This circuit replaces the reset logic of the sweep generator by simply plugging into the 74LS90 socket on the PCB and adding a +15V supply pickoff to the main board. J1 is a 14-pin ribbon cable jumper to that socket. The sweep generator reset transistors and resistors should be removed, as well as the +5V dropping resistor and filter capacitor.

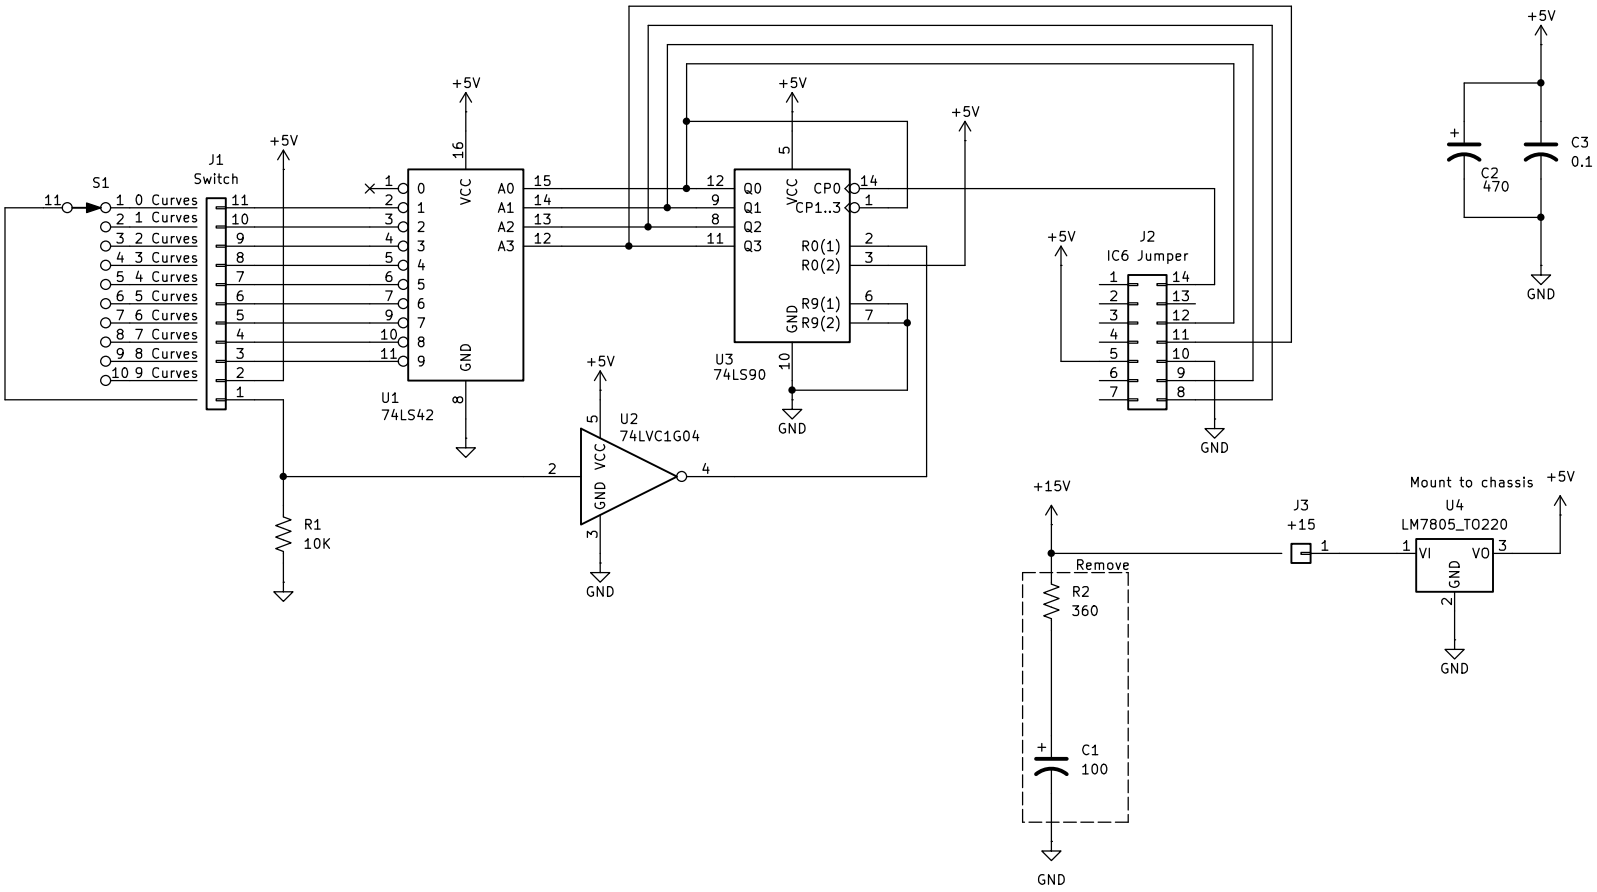
1. The 7.5M potentiometer used in the original circuit is no longer available. This circuit changes from a current sense reset circuit to a digital BCD code reset. It uses a 10 position rotary switch to set the number of curves desired. The switch has positive detent stops which are more precise than fiddling with a potentiometer and offers repeatable and accurate setting.
